SUBJECT: Quail Ridge Addition Comments DATE: 7/27/84

Re: Quail Ridge Addition

PRELIMINARY PLAT
QUAIL RIDGE ADDITION
 CITY OF ROCKWALL
 ROCKWALL COUNTY, TEXAS

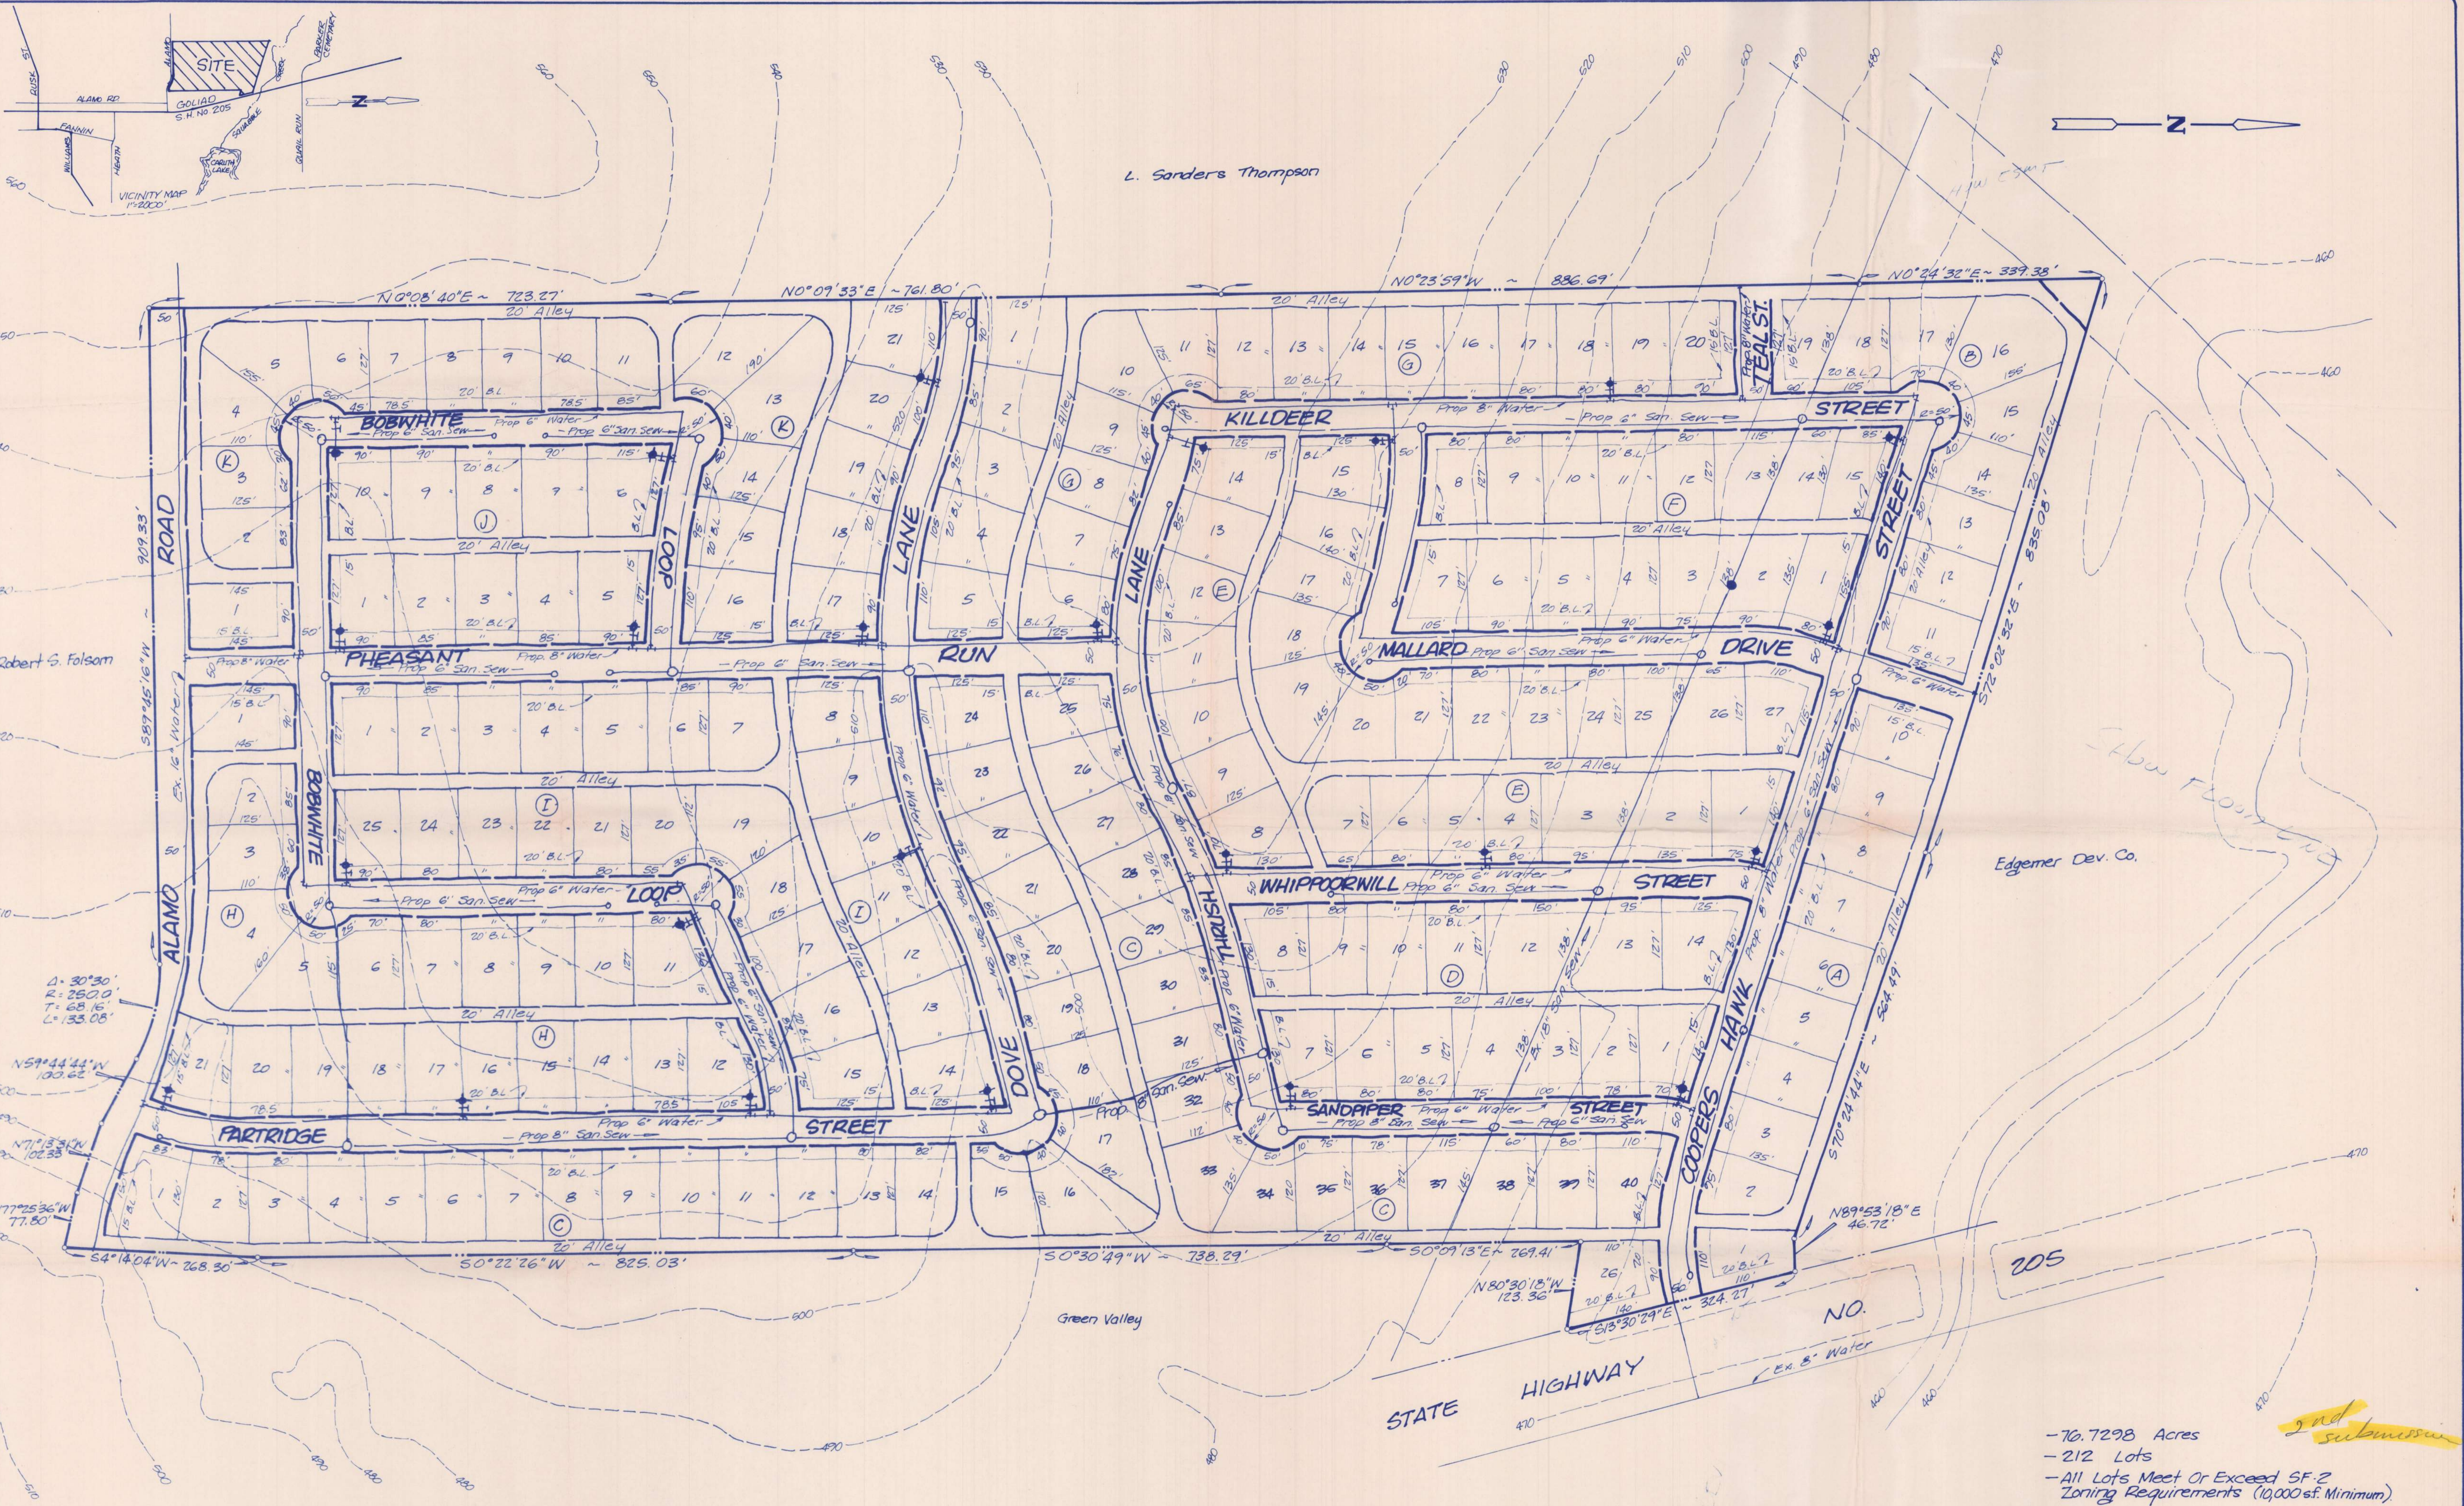
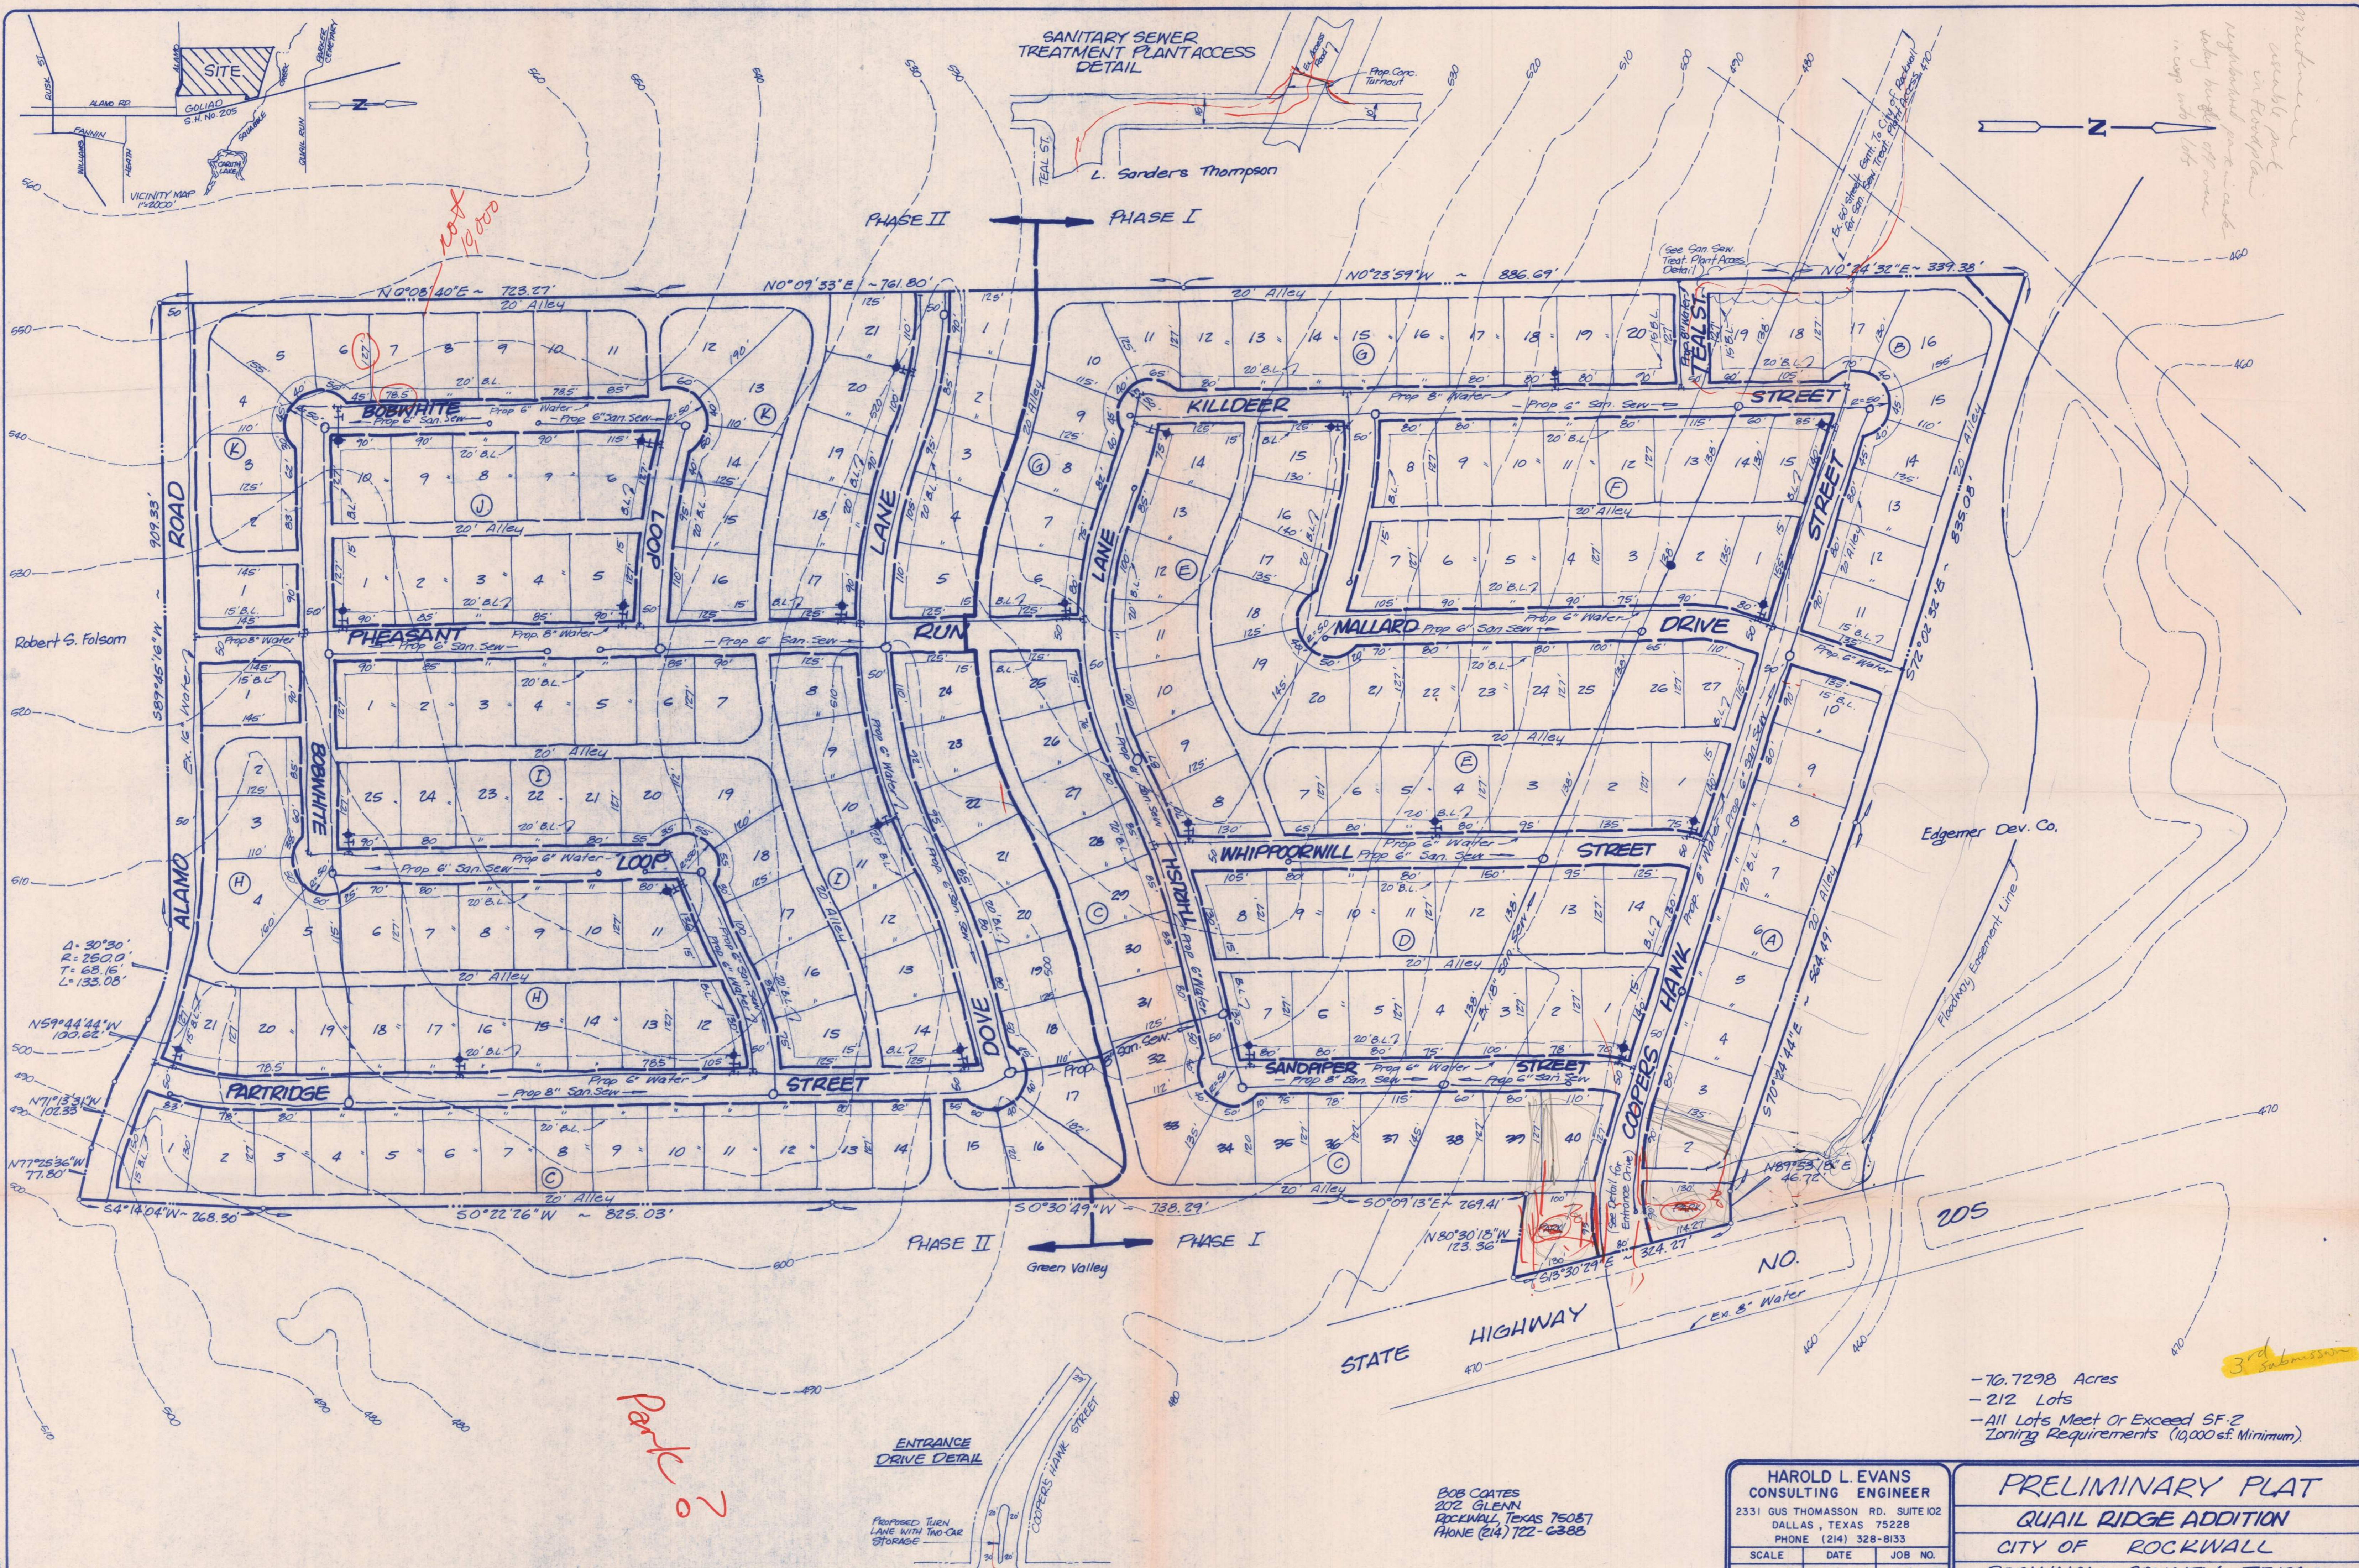
- 1. Area contains some land zoned Commercial which must be rezoned.
- 75 2. All lots must be 10,000 sq. ft.
- 3. City must have access to sewer plant.
- 4. 16" water line on Alamo must be activated.
- 5. Dove Lake stub unuseable - existing lots.
- 6. Alamo Road must be improved.
- 7. Access to SH-205 must meet City design standards, not too steep.
- 8. Flood plain study needed.
- 9. Route survey for proposed extension of Lakeshore Drive needed.
- 10. Quail Ridge Drive too similar to Quail Run Road; Mallard Drive, rename N-S Thrush Lane; Partridge Street, Bobwhite Loop.

On August 9, 1984, the Planning and Zoning Commission voted to table your preliminary plat until access to the sewer plant is resolved, the project is divided into two phases, and the entrance to SH-025 is designed and it is determined whether the two lots adjacent to the road are useable. All Staff comments provided earlier also apply. To appear before the Planning and Zoning Commission again on September 13th, please submit 8 copies of the revised plat by August 27th.

MESSAGE:
- On September 13, 1984, the P&Z approved your preliminary plat subject to:
1) all lots enlarged to minimum 10,000 sq. ft.
2) commercial areas rezoned to SF-10
3) final plat of Phase 2 subject to route study and improvements to Alamo Rd.
4) Lot 1, Block A incorporate park area with alley relocated and large side setback
5) Park area on south side of Coopers Hawk Street removed from plat

MESSAGE:
- On October 1, 1984, the City Council approved your preliminary plat subject to the Commercial area being rezoned to "SF-10" and the final plat of Phase 2 subject to a route study and improvements to Alamo Road. You still must bring all lots up to 10,000 sq. ft.
